**PLAN COMMISSION PC #22-008**  
**Ecole 360 Child Development Center**  
**1515 W Dundee Road**  
**Round 2**

# Planning & Community Development Dept. Review

Project: Ecole 360 Childcare  
1515-1519 W. Dundee Rd.

Case Number: PC 22-008

**Proposed location for Bike Rack:**

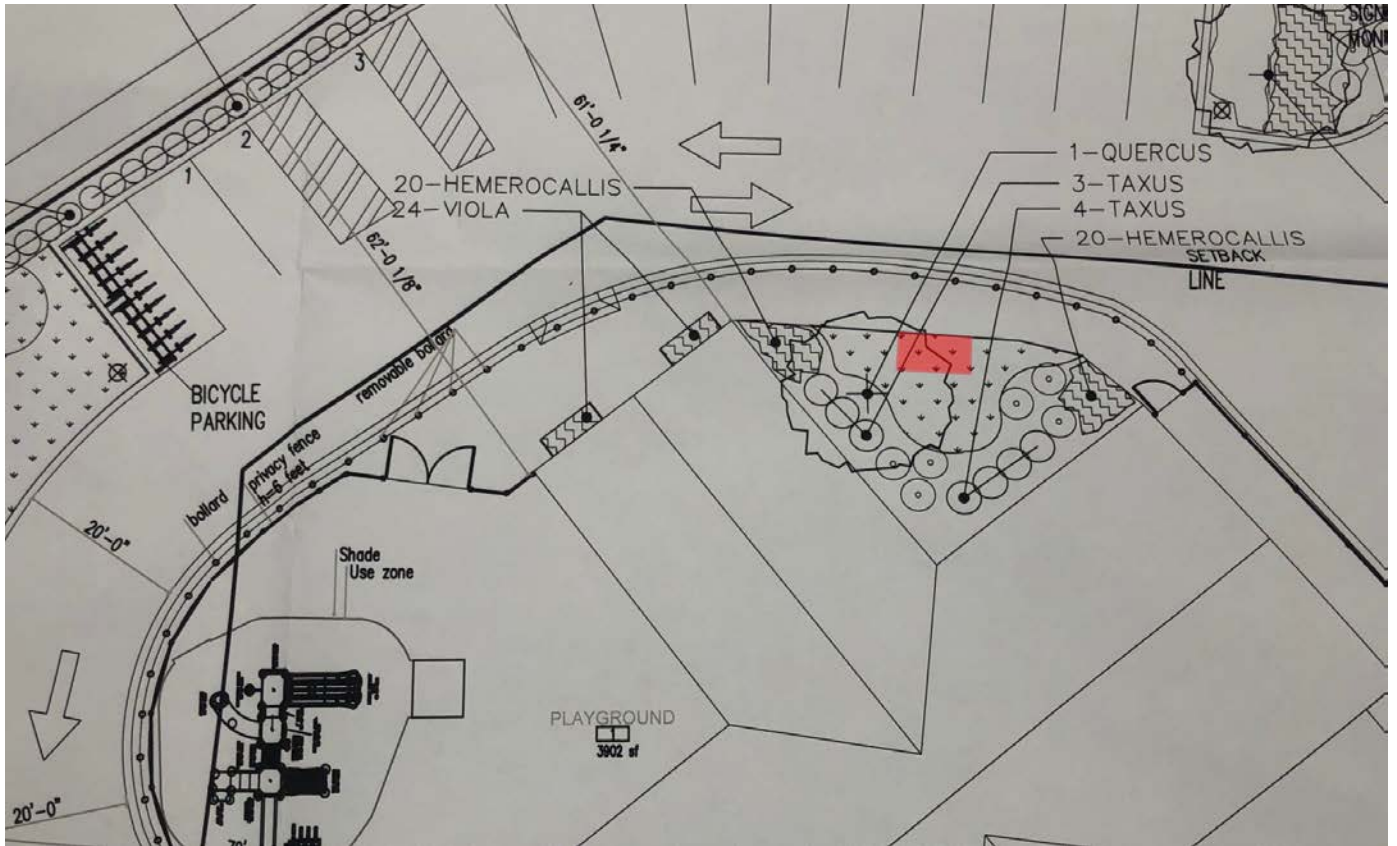
36. It is encouraged to relocate the proposed bike parking spaces to a small concrete pad added to the greenspace at the front of the building (see next page for general area of bike rack). This would preserve a prime automobile parking spot for drop-off/pick-up parking. Per code, only 2 bike parking spaces are required, which could be satisfied with a U-shaped bike rack (see example on next page). Is there a reason why 10 bike parking spaces have been proposed where only 2 bike parking spaces are required by code?
